Contract HK 12/02
Central Reclamation Phase III – Engineering Works
Environmental Permit No.: FEP- 01/122/2003

**Certification and Verification for Change of FEP Condition 3.2 –
 Concurrent Dredging/ Filing at FRAW & FRAE**

ET Leader's Certification

Sketch B

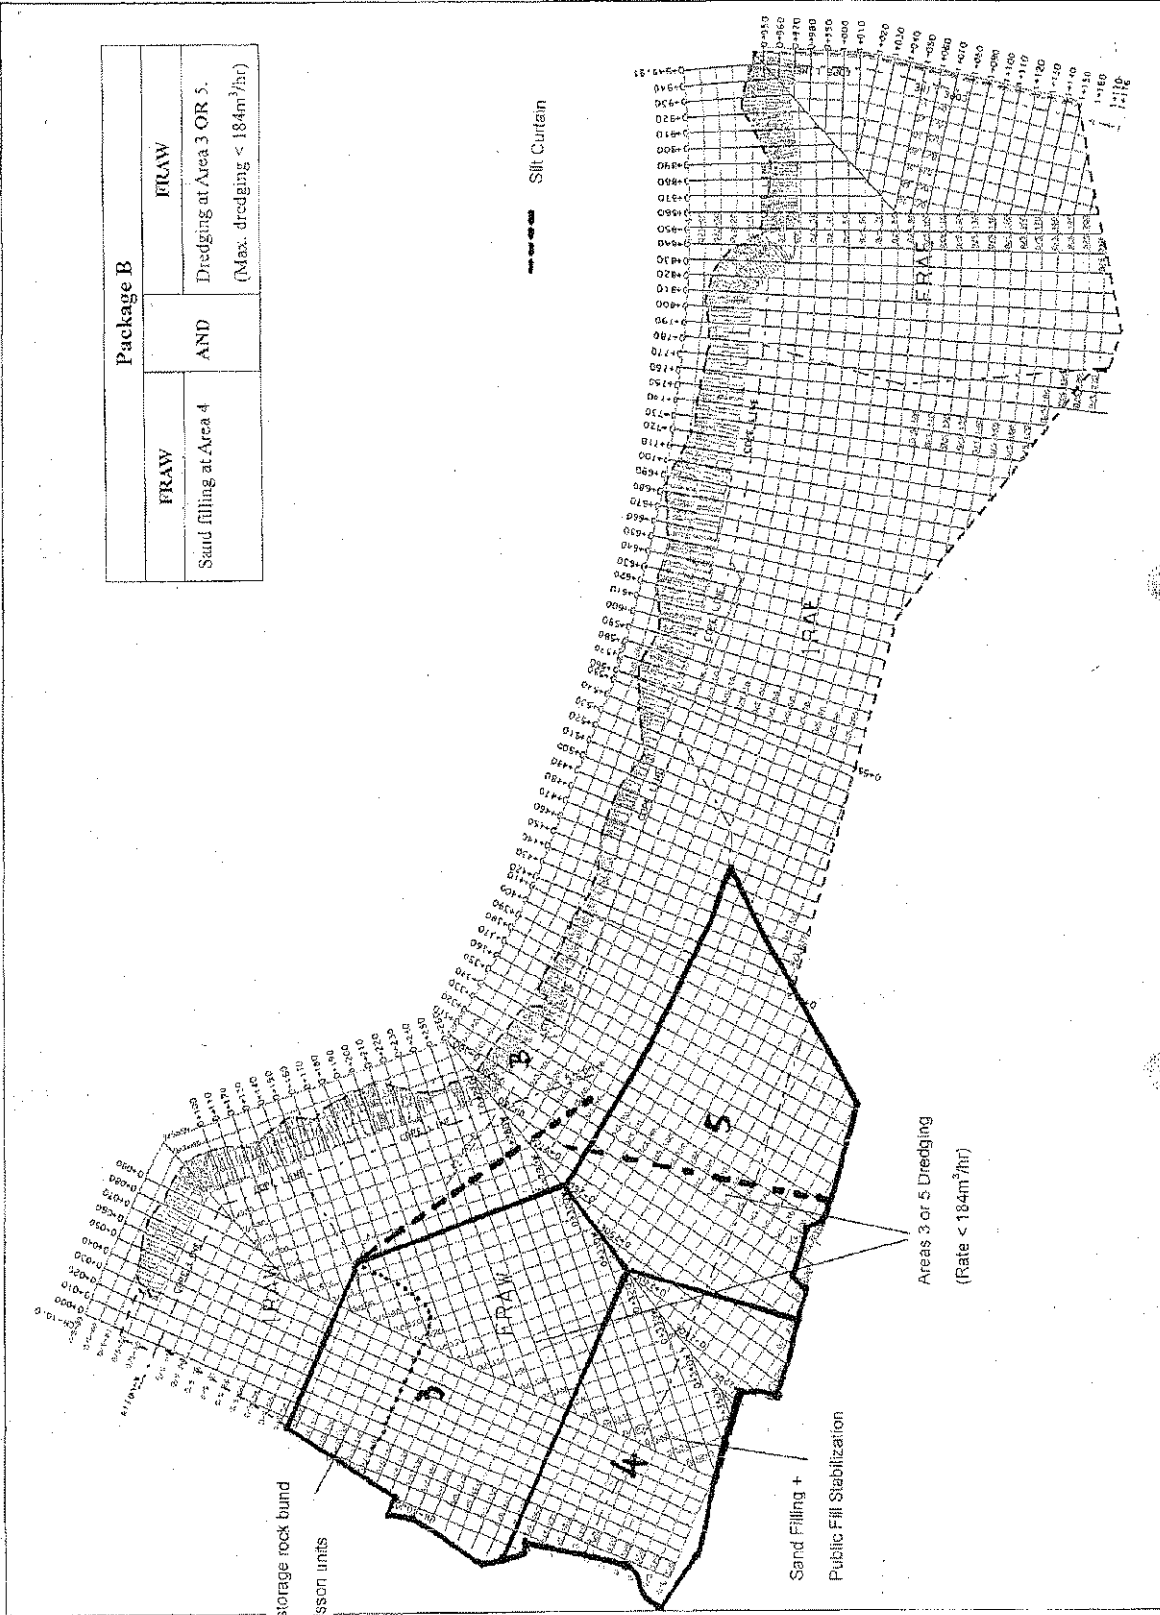
Package B: Concurrent Dredging and Filling at FRAW (Sketch B refers)

FRAW	FRAE
Sandfilling in Area 4 together with sand slope stabilization by Type A materials + concurrent dredging at Area 3 OR 5 at maximum dredging rate not exceeding 184 m ³ /h	No concurrent sanding filling at FRAE

Package B	
FRAW	FRAW
Sand filling at Area 4	Dredging at Area 3 OR 5. (Max. dredging < 184m ³ /hr)

(1) The JV shall implement mitigation measures to reduce water quality impacts as stated in their referenced letter with regard to use of framed type silt curtain enclosing the area being dredged and floating curtains at the front and rear enclosing the gap between dredger and hopper barge.

(2) Dredging at FRAW shall not exceed the maximum rate of 184 m³/h prescribed in the FEP. This should be defined as the cumulated total from all dredgers, if applicable.

(3) For sandfilling works at FRAW or FRAE, two overlapping silt curtains with an opening for vessels movement shall be installed to enclose the sand filling area down to the seabed to avoid dispersion of fill materials as shown in Sketch A & B. These silt curtains shall be regularly inspected and fixed.

(7) For works at FRAW, sandfilling should be limited to Area 4 together with the necessary fill slope stabilisation by Type A materials only. Further restrictions on filling works in the FEP - Clause 3.3 shall apply.
